Product Change Notification: PCN-23-169908 PCN Date: 21-MAR-23

SFP PLUS AND ZSFP PLUS CAGE ASSEMBLY, WITH PIN TYPE HEAT SINK

The cage with Nature Anodize Coated Heatsink

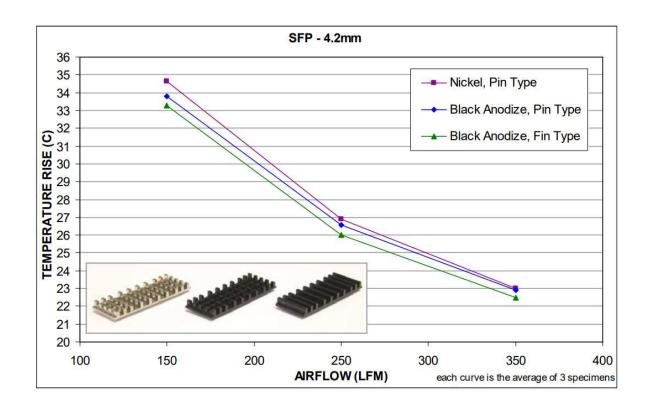
Changing heatsink from electronic nickel plating to Nature Anodize coating

Using plug to perform 5 & 10 cycles mating & un-mating tests, there is no obviously difference.
